TECHNICAL SERVICE BULLETIN

RE: Notice of Campaign Service Bulletin: **CSB11-270-001**

CAMPAIGN SERVICE BULLETIN

SUBJECT: Cooling – Hydraulic Filter Head

FILTER HEAD
FIG. 2-1

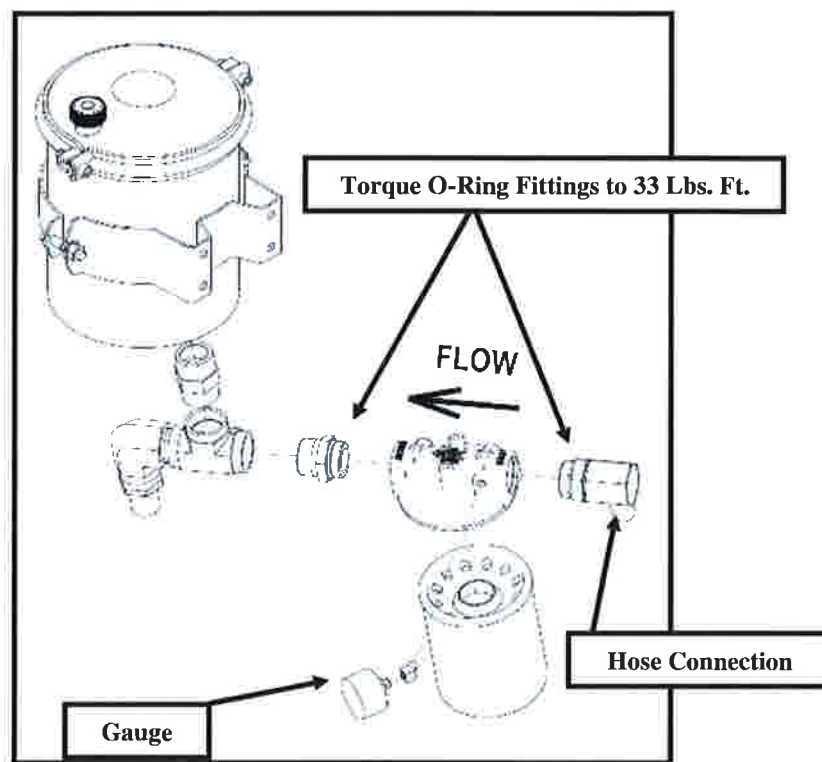
CONDITION: Hydraulic Filter Head Flow Reversed

1. Locate hydraulic reservoir.
2. Refer to FIG. 2-1. Inspect for flow direction. Flow arrow on top of filter head must be pointing towards reservoir, if arrow is pointing towards reservoir no further work is required. If arrow is pointing away from reservoir continue with instructions.

11. Refer to FIG. 2-1. Install new filter head reusing O-ringed fittings. Torque fittings to 33 lbs. ft.

12. Refer to FIG. 2-1. Reinstall fitting and gauge into filter head.
13. Refer to FIG. 2-1. Reconnect hose to barb fitting, secure as needed.
14. Refer to FIG. 3-1. Reinstall sensor in hydraulic cooler, secure as needed.
15. Fill system with AW46 Hydraulic oil or equivalent. Approximately 3 gallons.
16. Start unit and let idle for 10 to 15 minutes, shut off and refill as needed.
